Manchester, King Street

Planning update

Planning Permission and Listed Building Consent were received (with conditions) on 7th January 2022 for the proposed scheme.

Updates to the design that are required to meet current regulations and standards, and to future-proof the sustainability of the scheme are as listed below.

Section AA

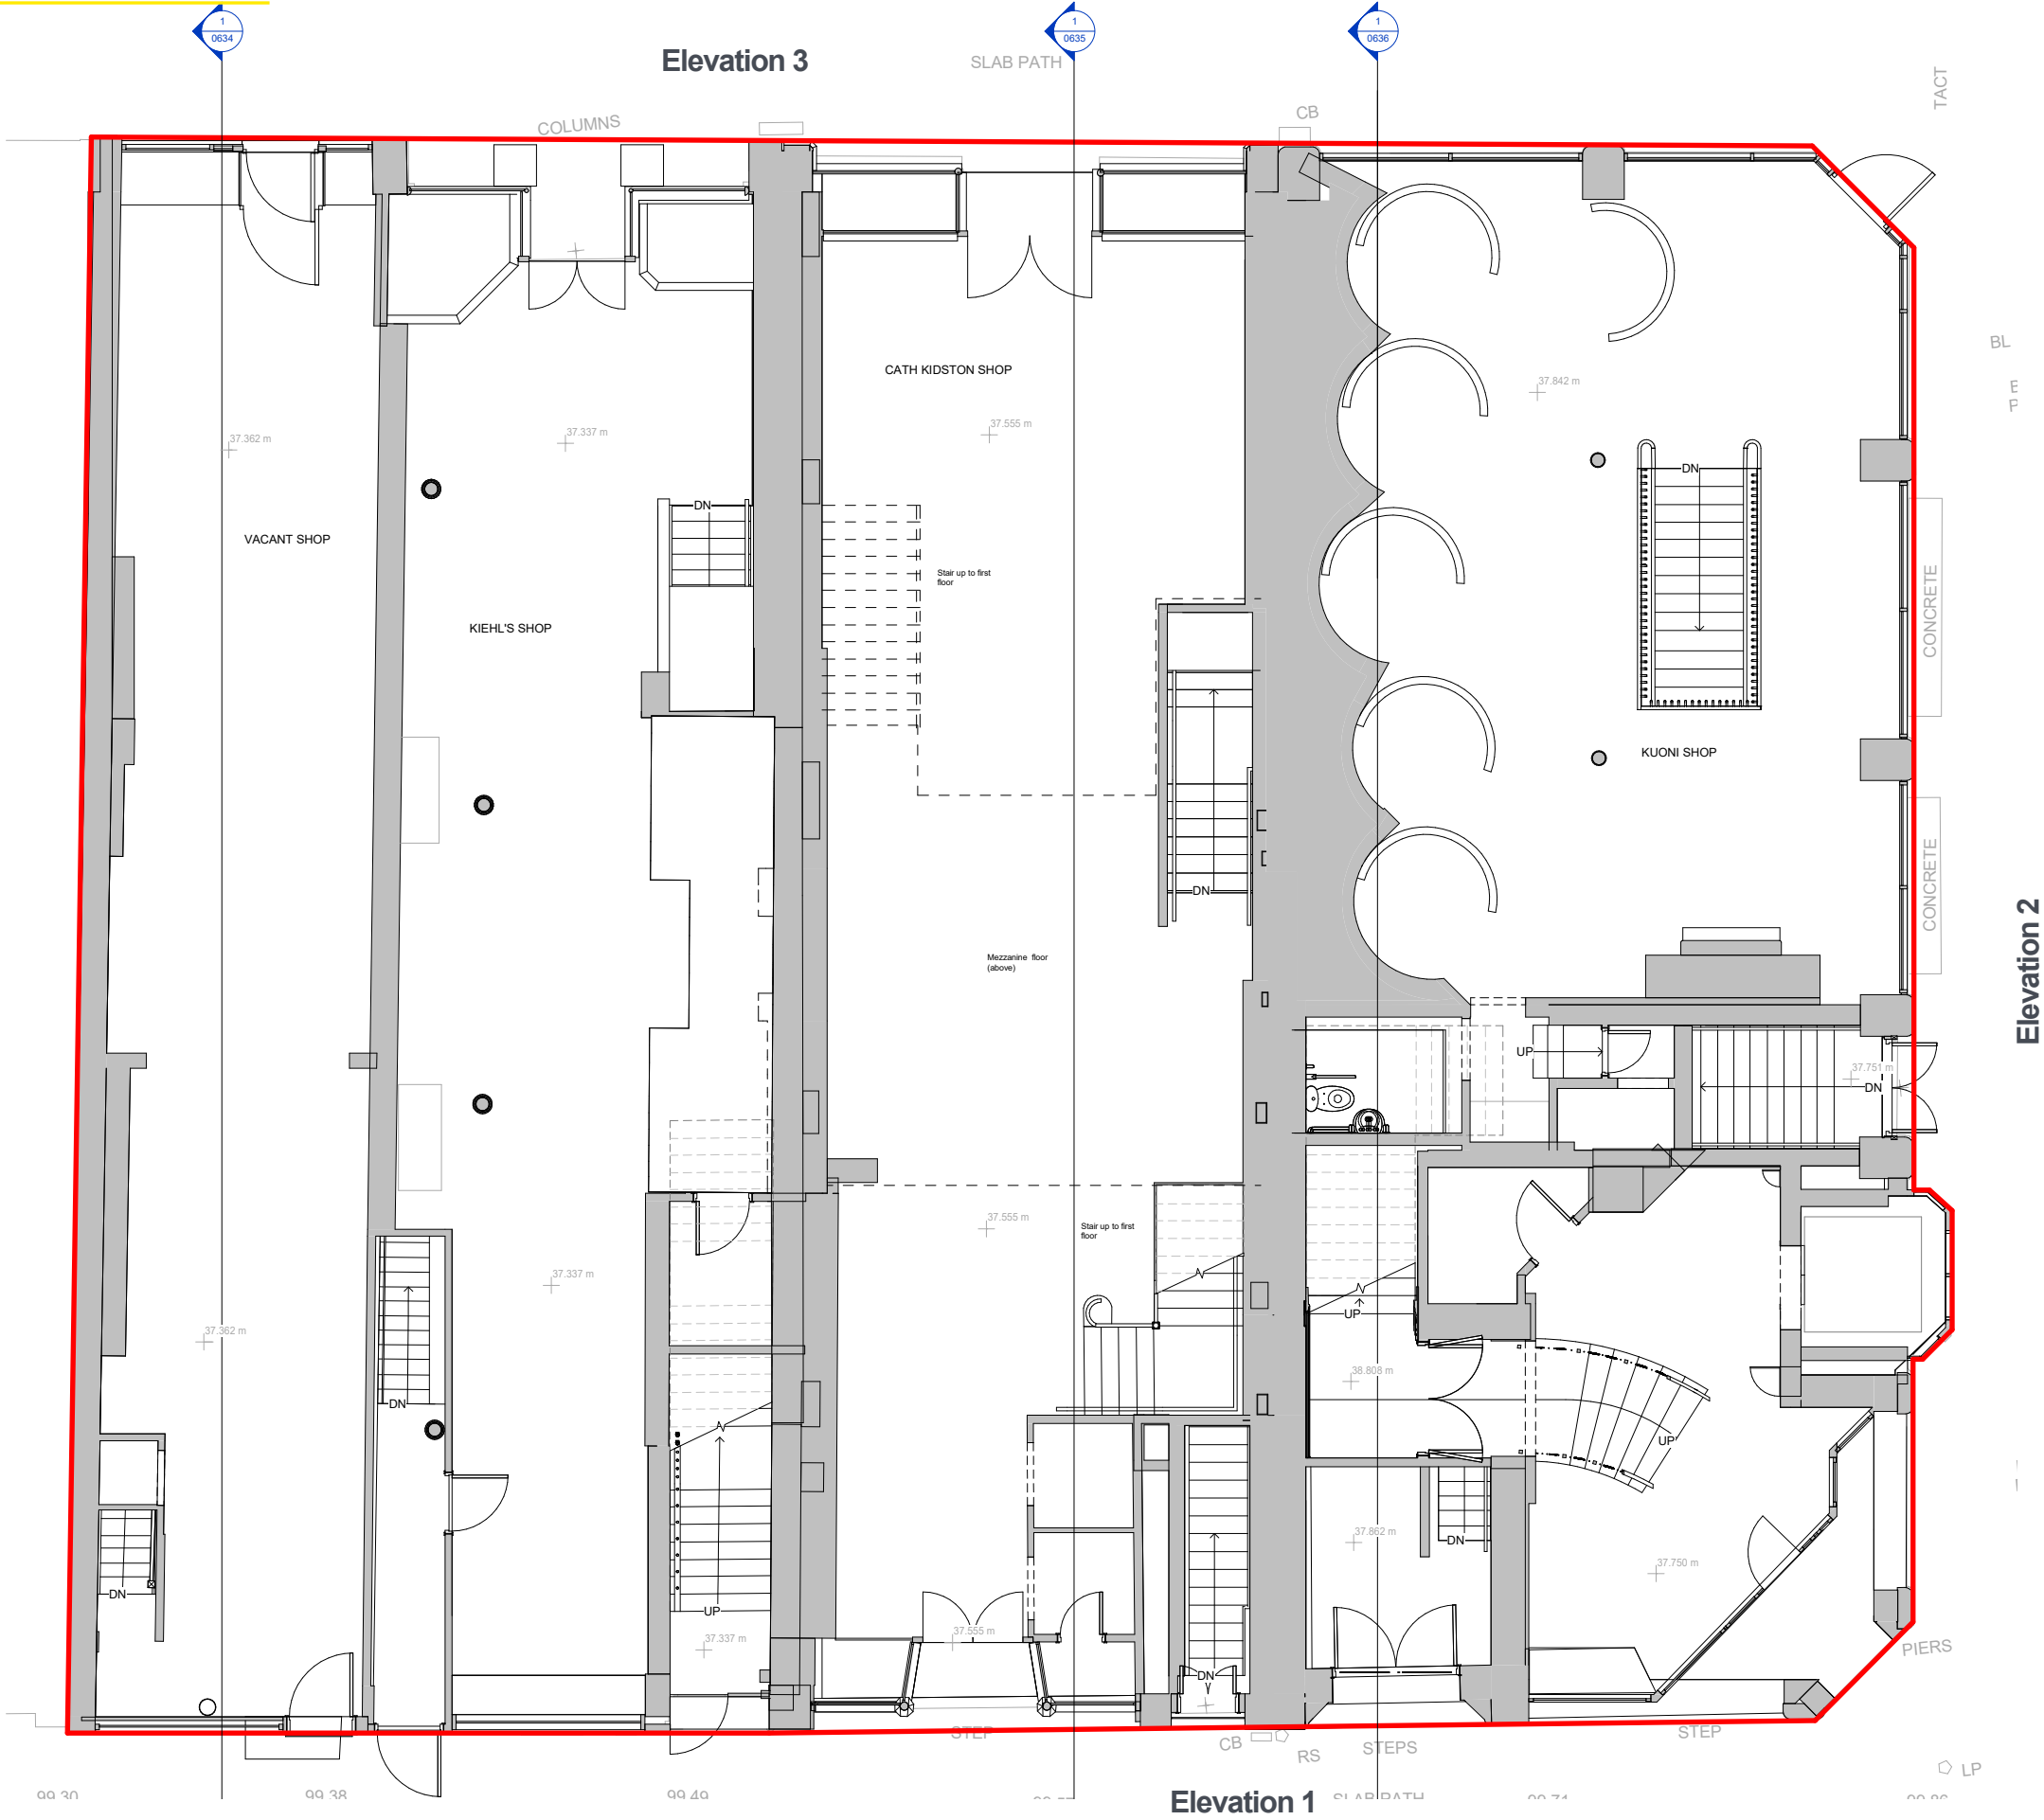
The purpose of this concept section is to show the relationship of the new wall and ceiling lining with the existing external window openings and typical new secondary glazing

Amended GA Ground Floor Plan Proposals

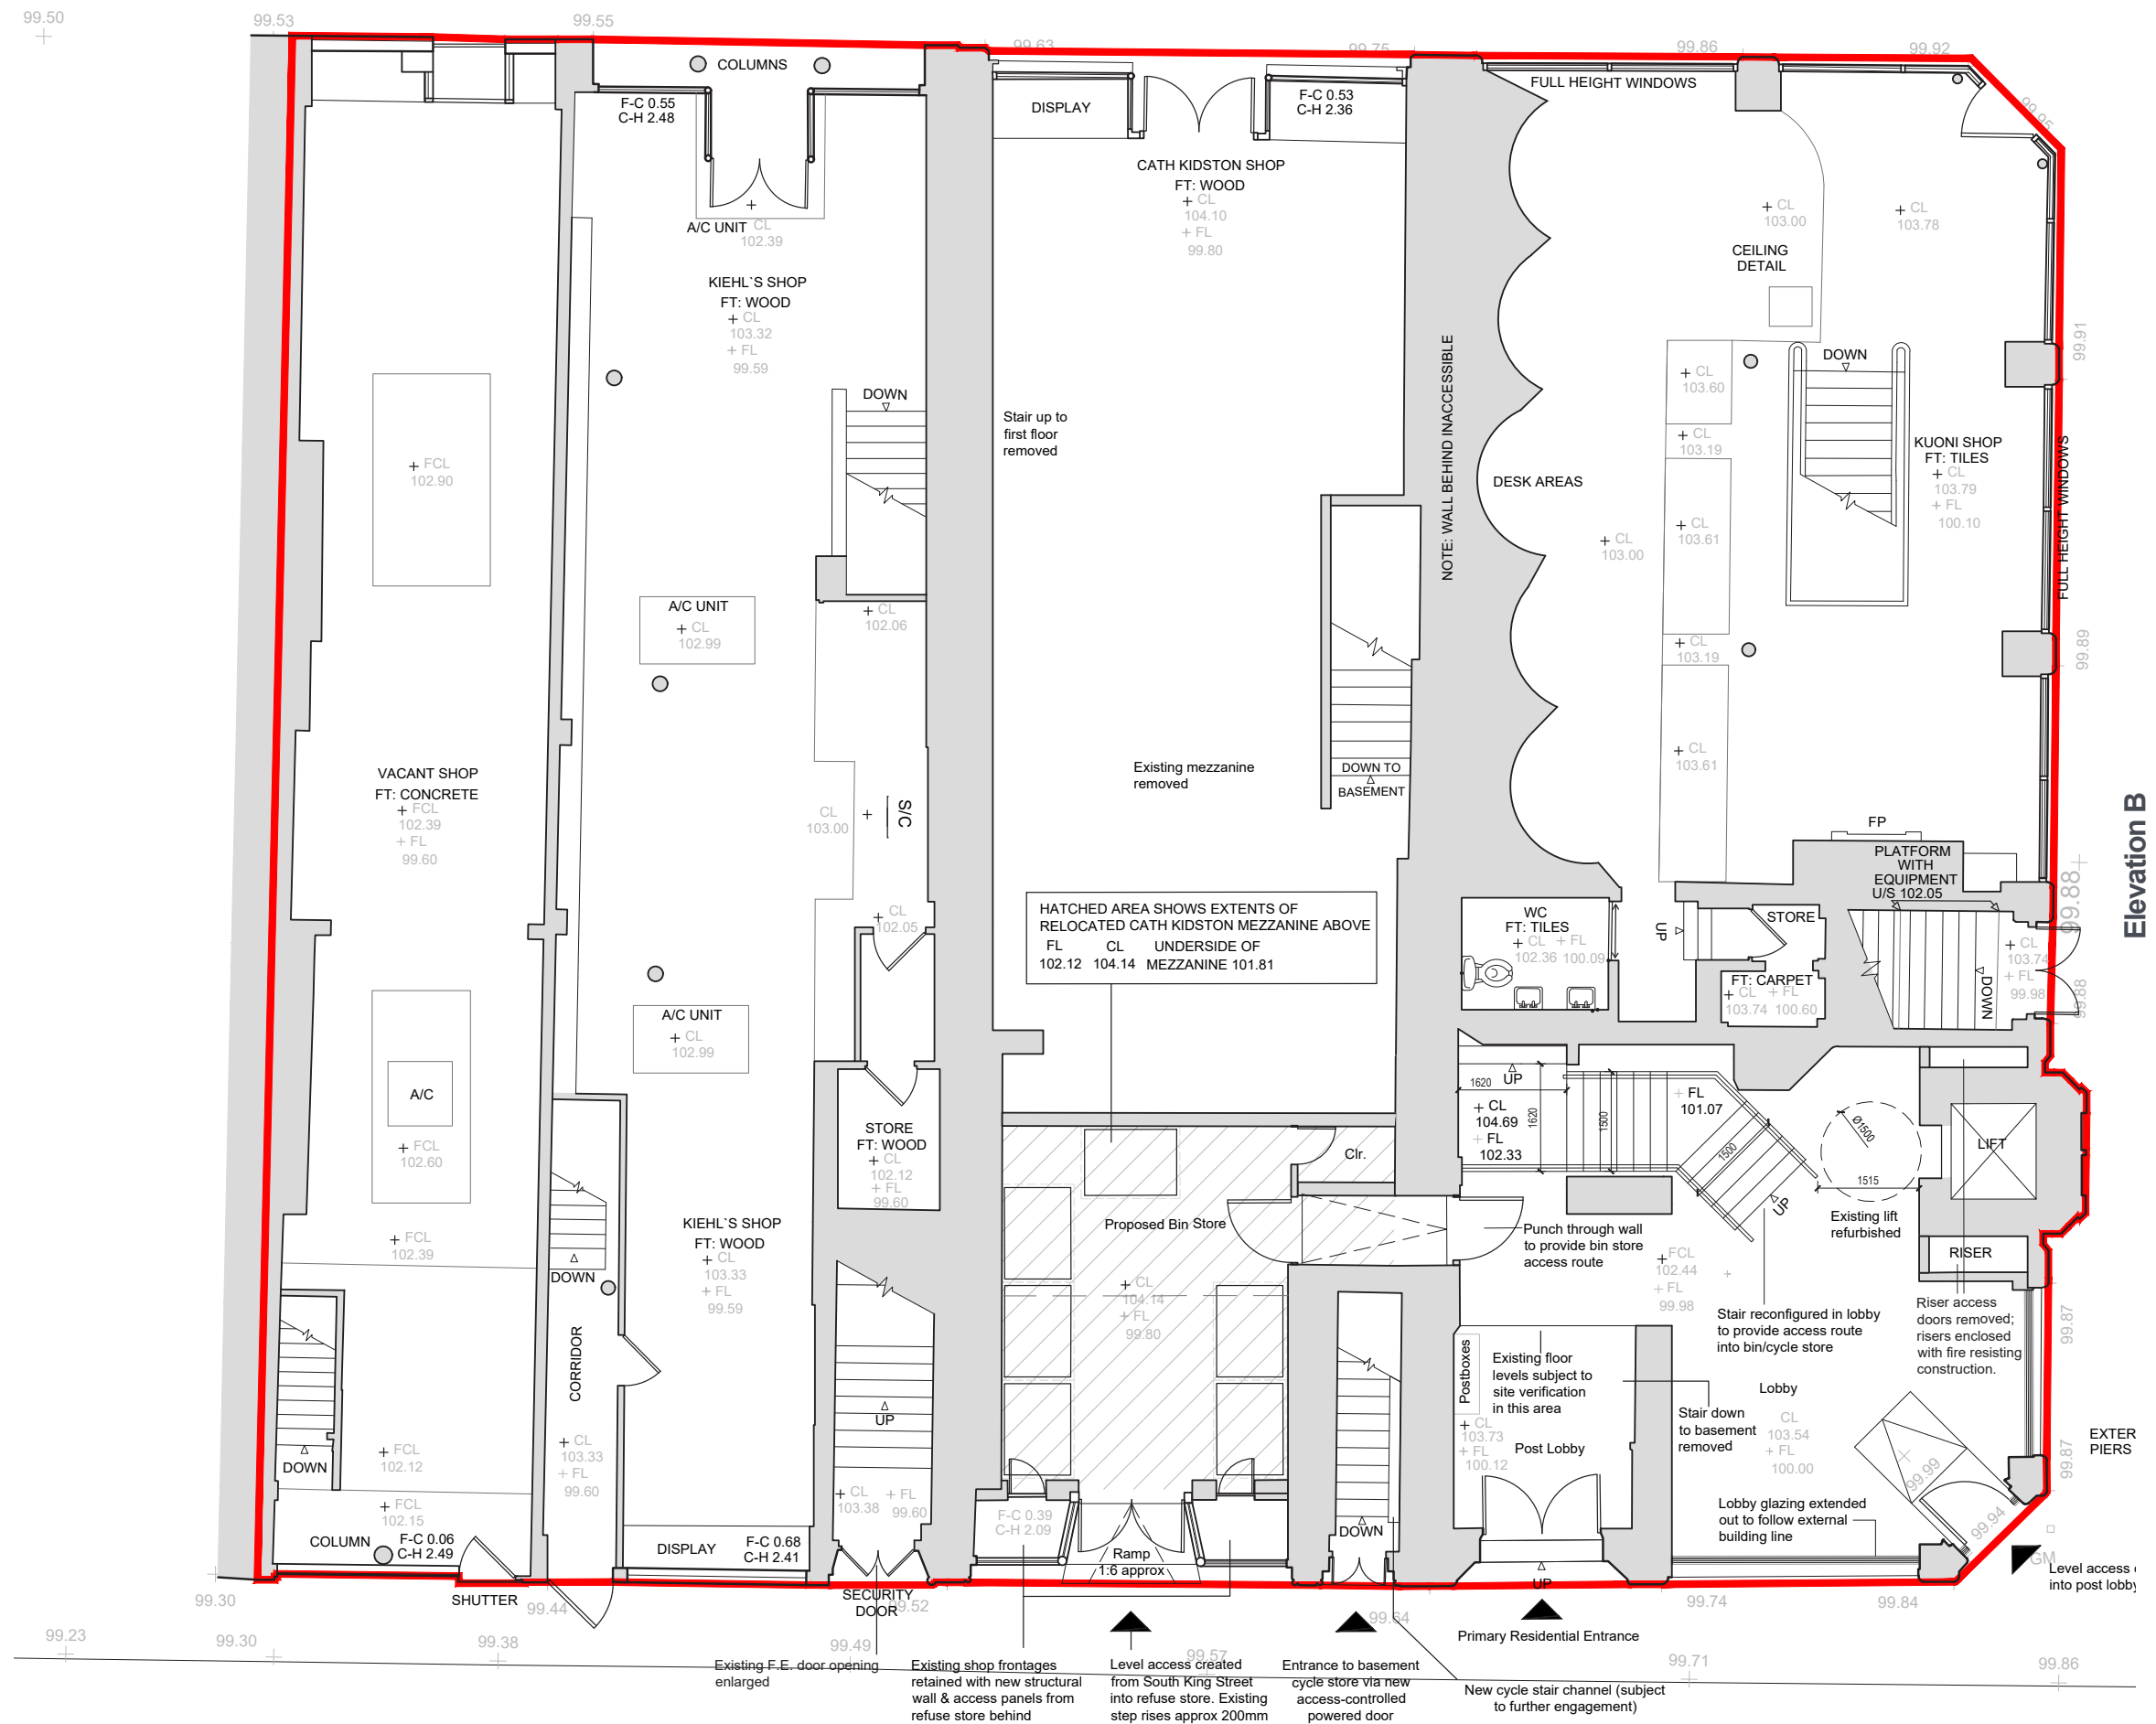
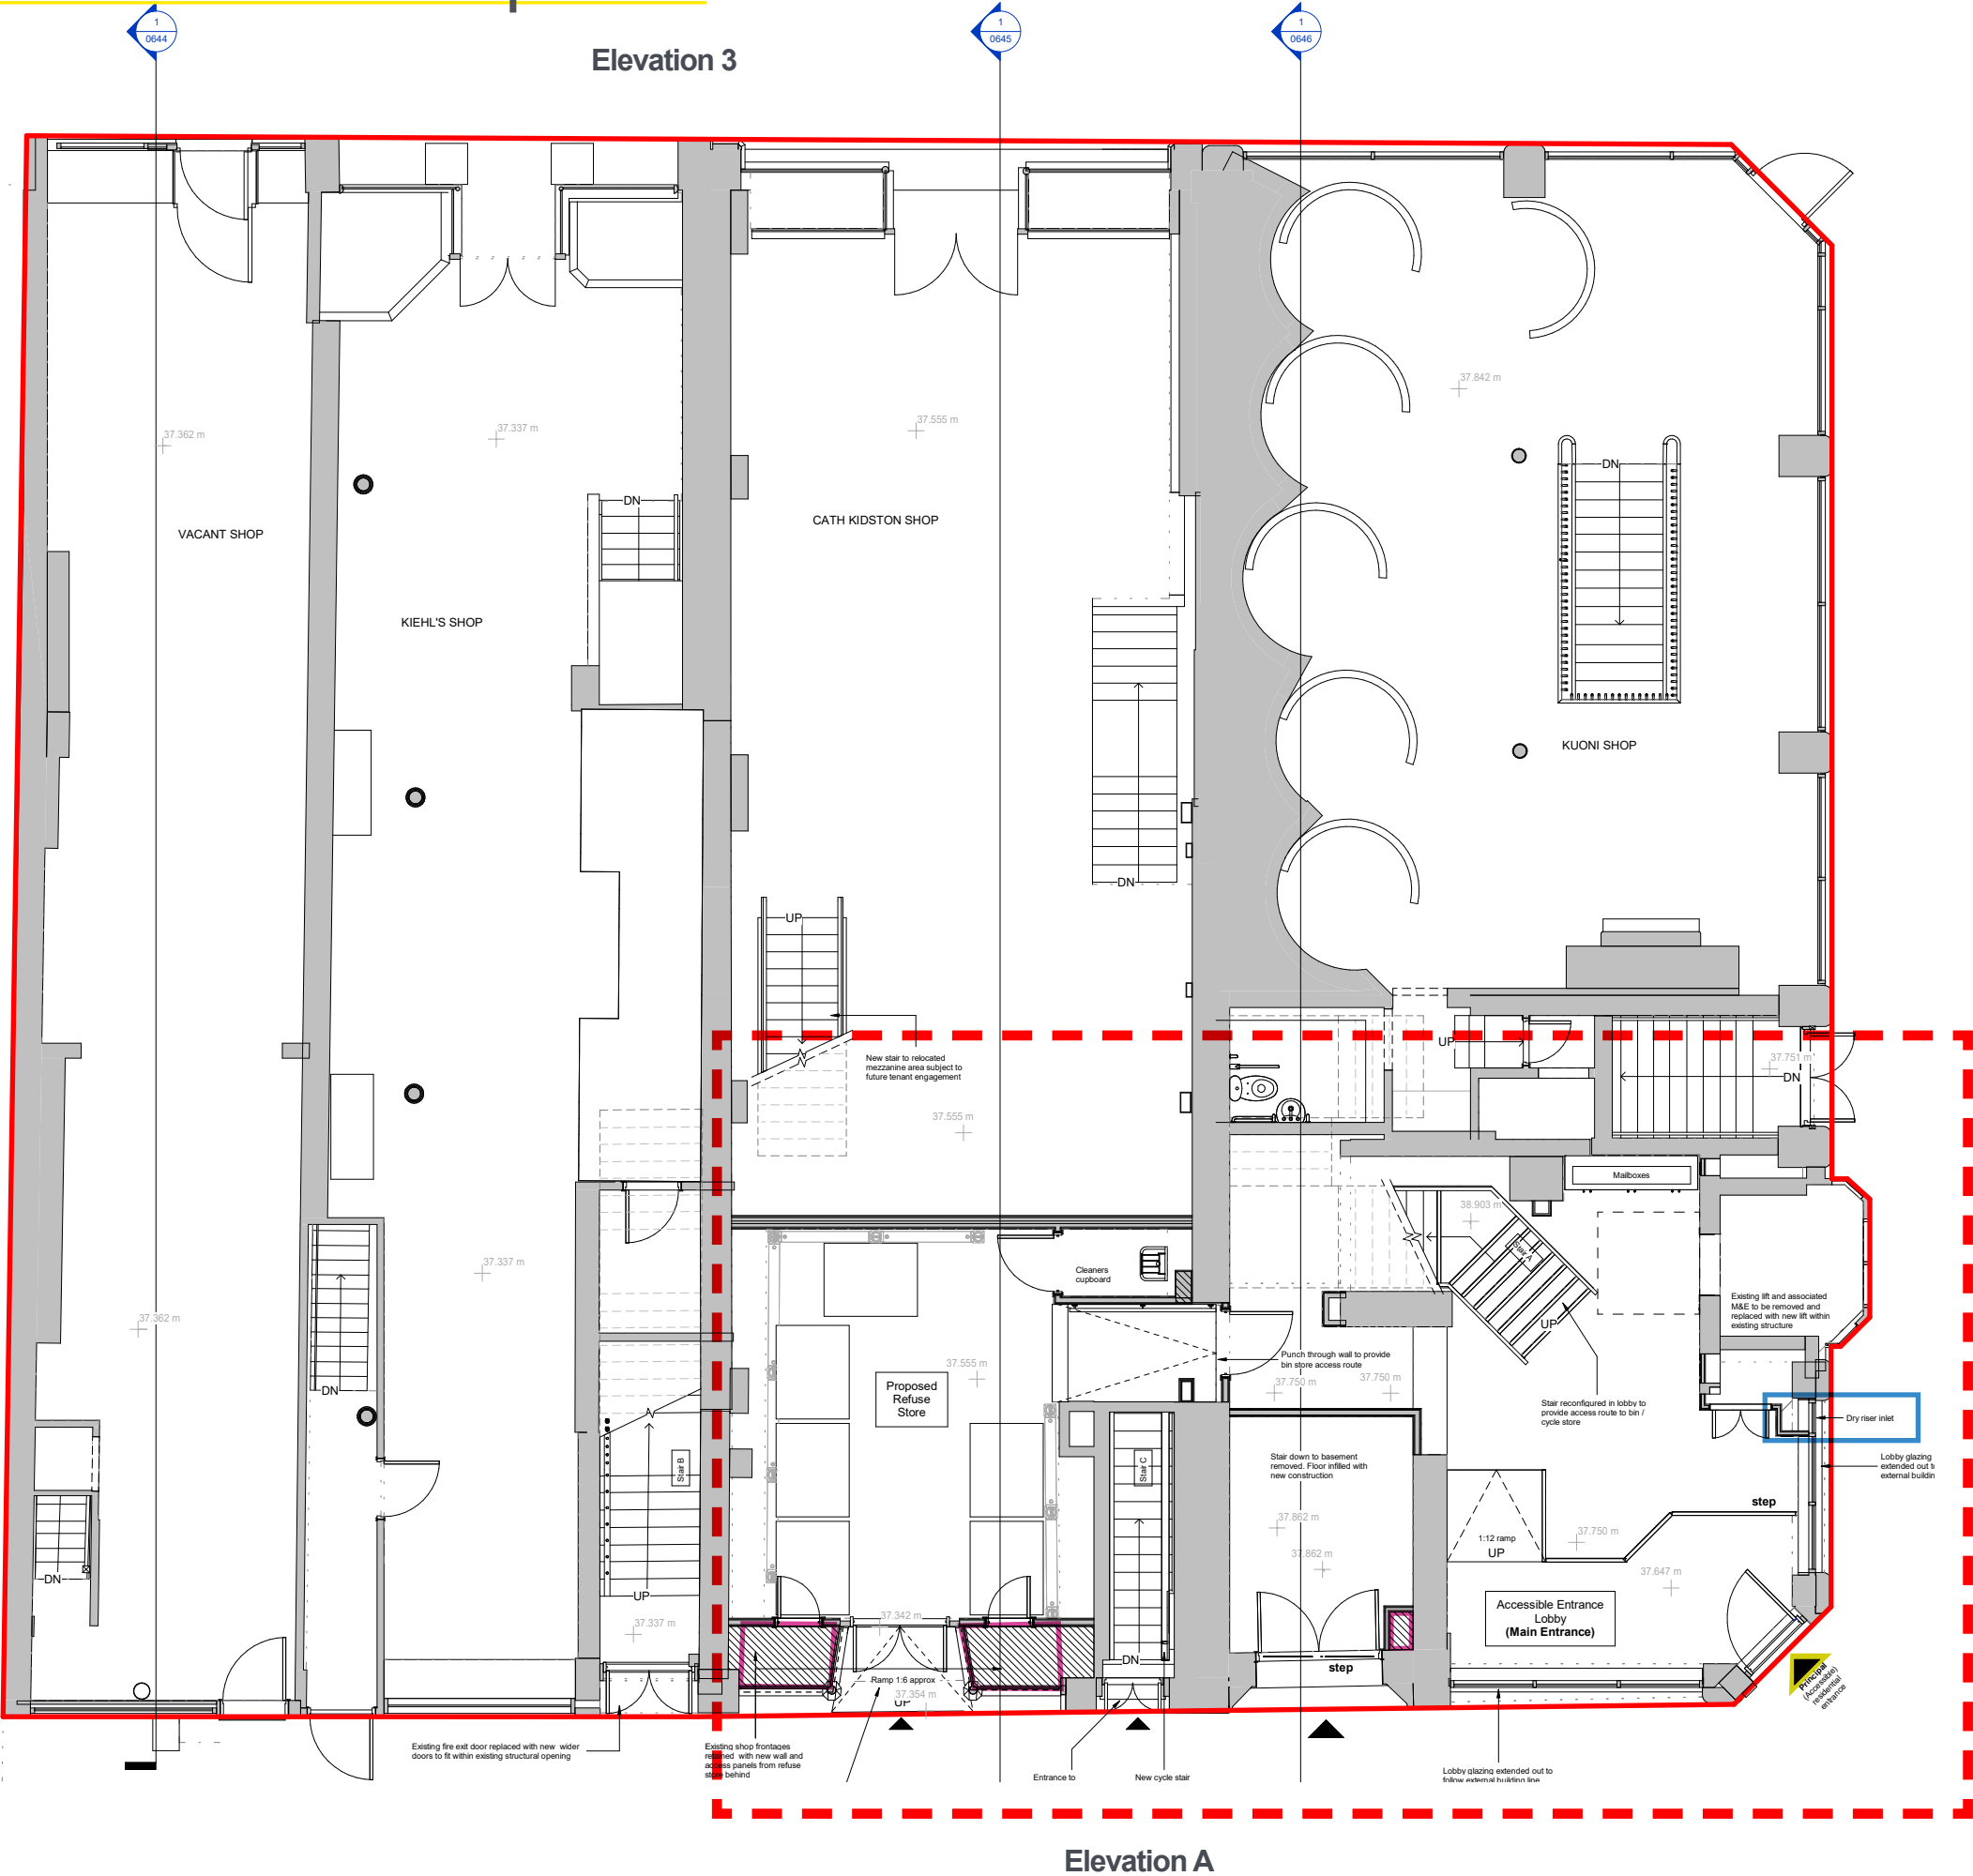
- Residential entrance reduced from 2no. to one single accessible entrance
- Basement ventilation ducts reinstated and introduced
- Dry riser inlet added

- Main Entrance
- Permanent ventilation required to basement via louver vents on ground floor elevations.
- Dry riser inlet
